May 2025 | Response to Comments

LANDFILL GAS TO ENERGY PLANT PROJECT

for City of Newport Beach

1. RESPONSE TO COMMENTS

Figure 5: Full Scale ALGEP Conceptual Site Plan with All Equipment Listed

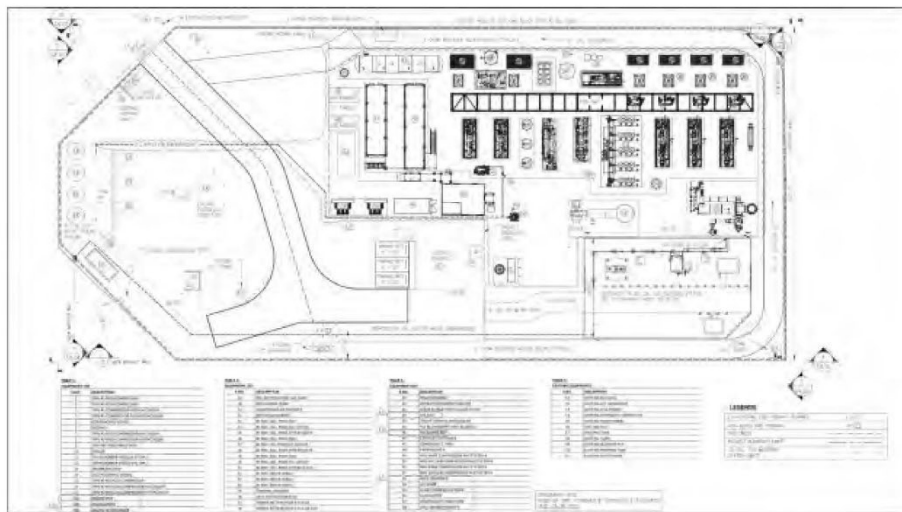
- **Flaring/Blowdown, Pressure Relief Valves, and Process Drains:** These systems are designed to vent excess gases during operations but can result in unregulated releases of both criteria pollutants and GHGs, particularly in instances of malfunction or unplanned blowdowns.

O2A-9
cont'd

Figure 6: Enlarged View of ALGEP Conceptual Site Plan with Sources of Leaks Equipment Highlighted in Yellow

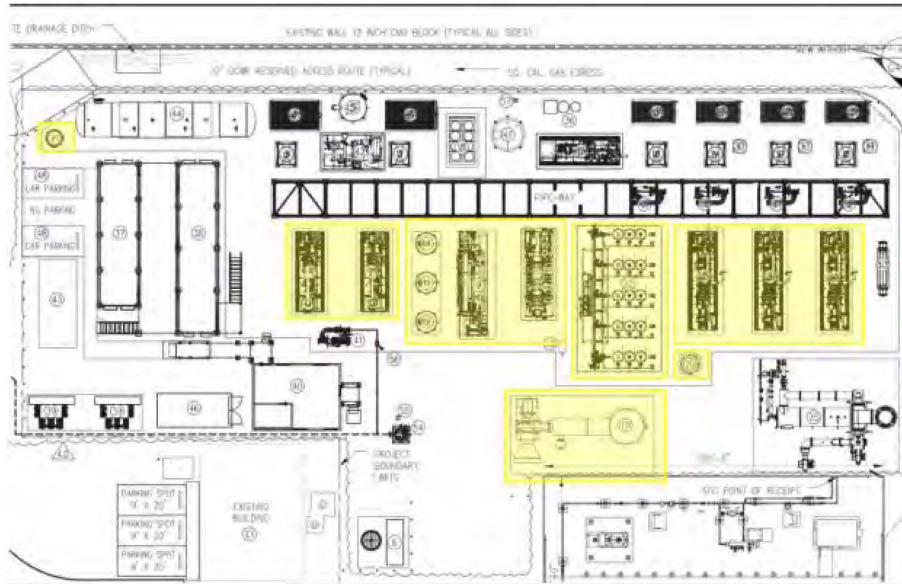
O2A-9
cont'd
